US-APWR DCD Revision 2 RAI Tracking Report

February 2010

This report includes a table that identifies the impact of each response to the Request for Additional Information (“RAI”) relative to the Design Control Document (“DCD”) Revision 2 of US-APWR. This table shows the RAI responses which have been submitted since October 2009 and also should be incorporated into Tracking Report and DCD in future revision.

The report also includes the DCD Markups and Revision List for the RAI responses that impacted the DCD.

Figure 6.2.4-1 Containment Isolation Configurations (Sheet 12 of 51)

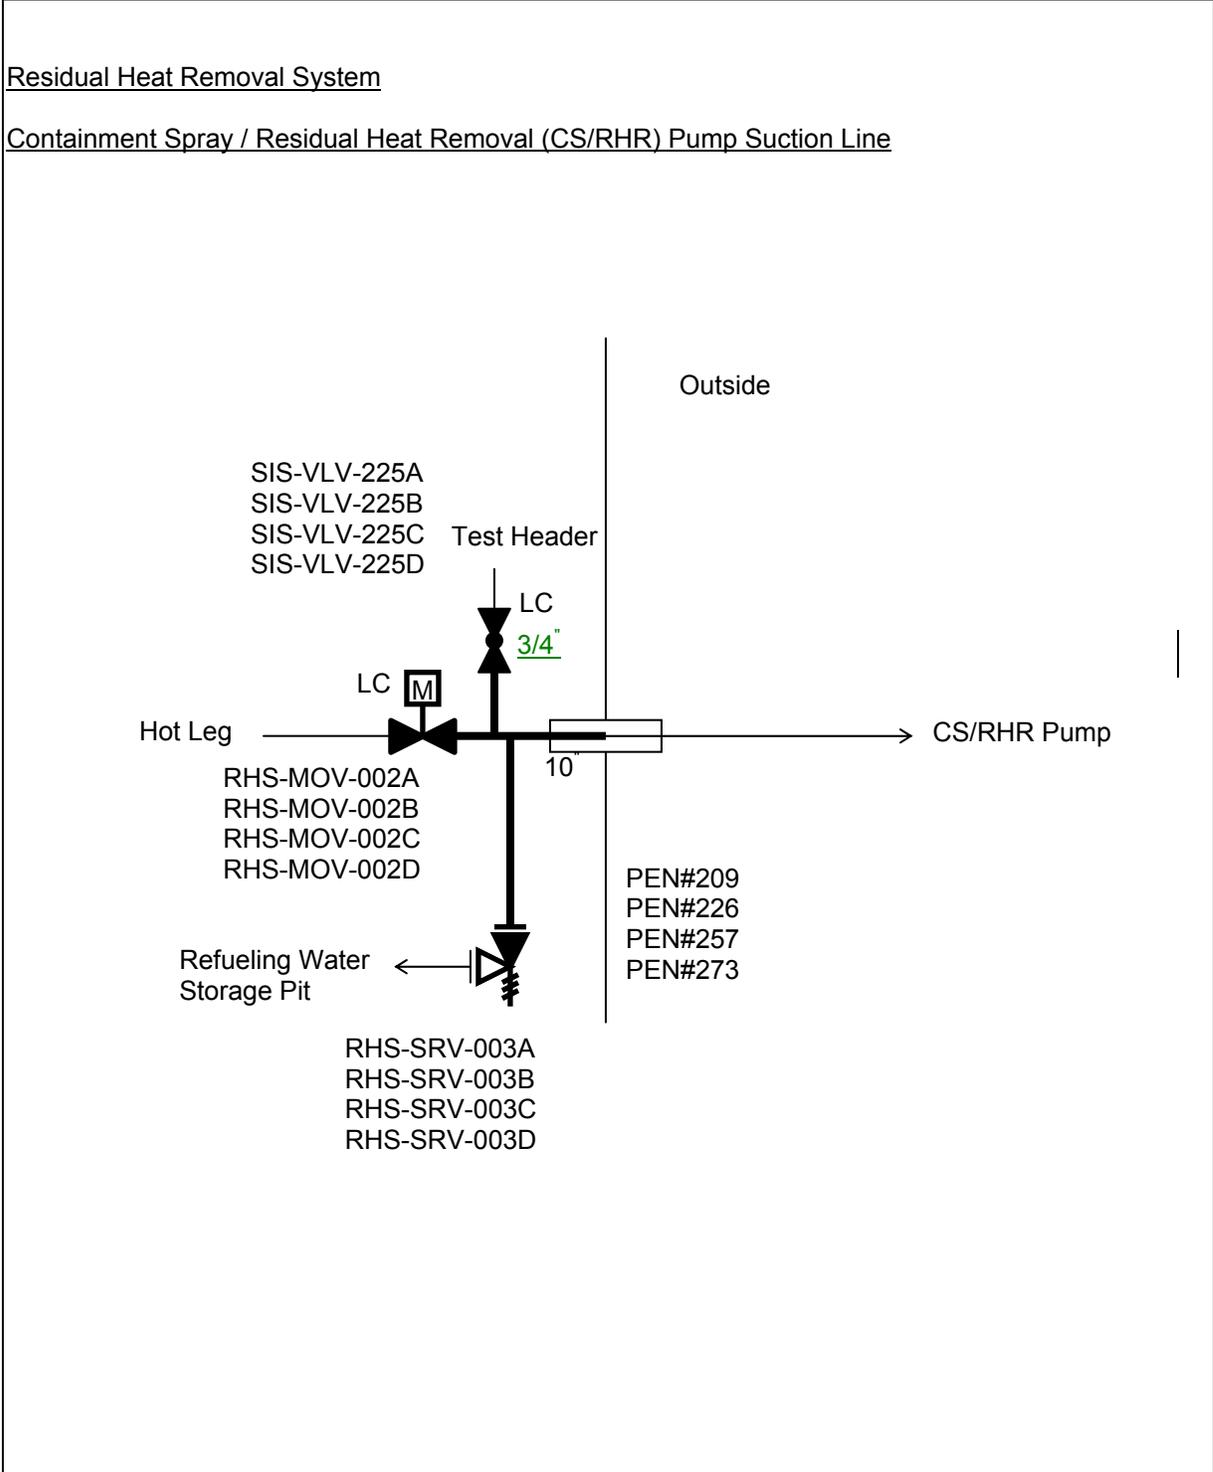
| Page | Location (e.g., subsection with paragraph/sentence/Item, table with column/row, or figure) | Description of Change |
|-----------------------|--|---|
| 6.2-315 | Figure 6.2.4-1 (Sheet 12 of 51) | Added “3/4” RAI 472, 06.02.06-24 |

Figure 9.5.4-1 Gas Turbine Generator Fuel Oil Storage and Transfer System Schematic Diagram

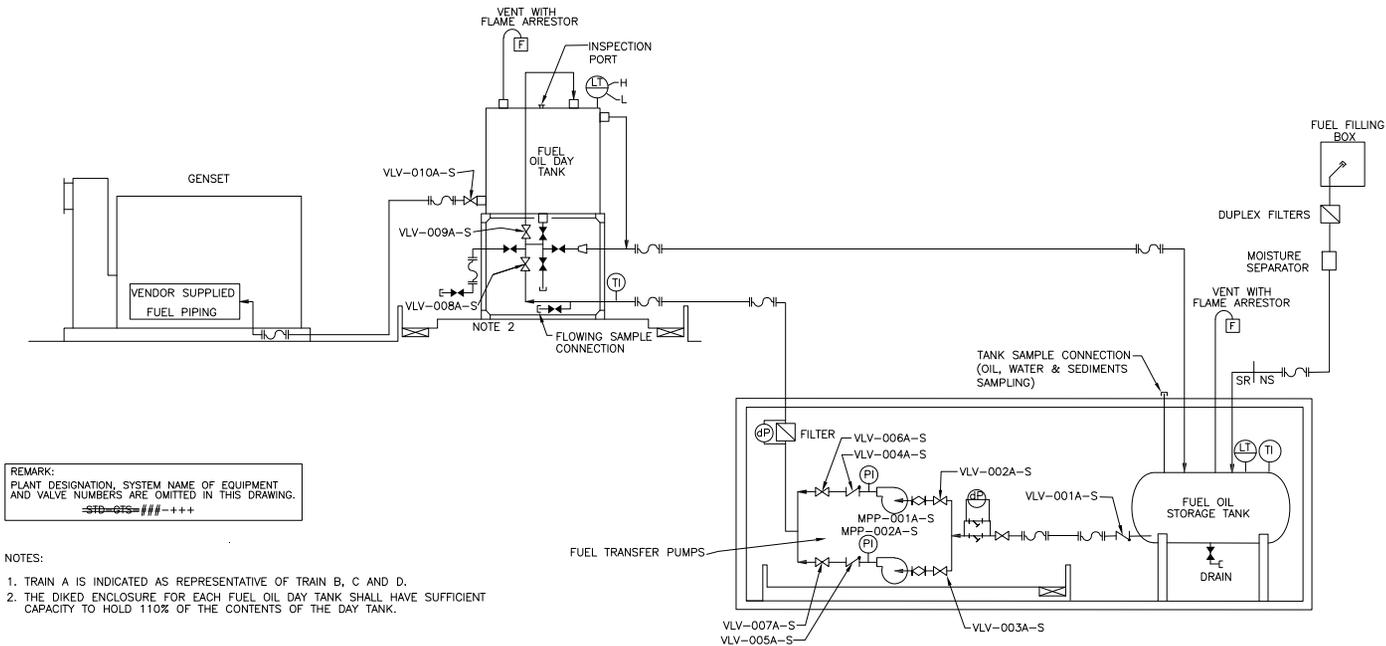
| Page | Location (e.g., subsection with paragraph/sentence/Item, table with column/row, or figure) | Description of Change |
|------------------|--|---|
| 9.5-159 | Figure 9.5.4-1 | RAI No.468 Question No.09.05.04-45 and 47 Changed: Flow sample location, Tank sample connection and Location of storage tank outlet Added: Note2 |
